MIL ON With DTC P0CDF72 (SAE Code P0CE0)

YEAR(S)	MODEL(S)	ADDITIONAL INFORMATION
2021	RAV4 Prime

REVISION NOTICE

February 02, 2022 Rev1:

Figure 1. Location of Authorized Modifications Label on 2021 RAV4 Prime

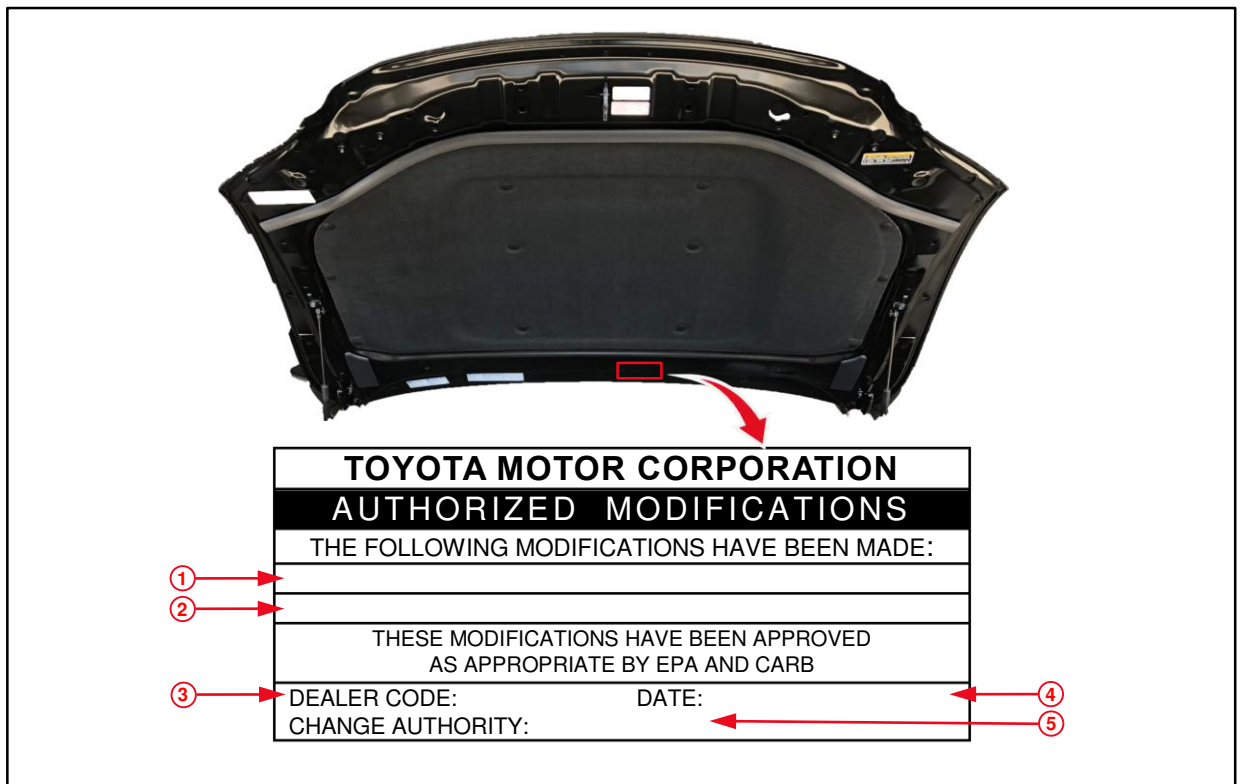
2. Check for the Authorized Modifications Label affixed to the vehicle in the location shown below. Confirm if the Amplifier Assy, Air Conditioner calibration has been updated.

Is the calibration ID listed the latest Amplifier Assy, Air Conditioner calibration?

4. Prepare and install the Authorized Modifications Label.
 - A. Using a permanent marker, enter the following information on the label:
 - Amplifier Assy, Air Conditioner part number [Refer to the **Parts Information** section for the **NEW PART NUMBER**]
 - Calibration ID(s) [Refer to the **Calibration Information** section for the **NEW CALIBRATION ID**]
 - Dealer Code
 - Repair Date
 - Change Authority [This bulletin number]
 - B. Affix the Authorized Modifications Label to the vehicle at the location shown in Figure 1. The Authorized Modifications Label is available through the MDC, P/N 00451-00001-LBL.
5. Test-drive the vehicle to confirm normal vehicle operation and the condition is no longer present.
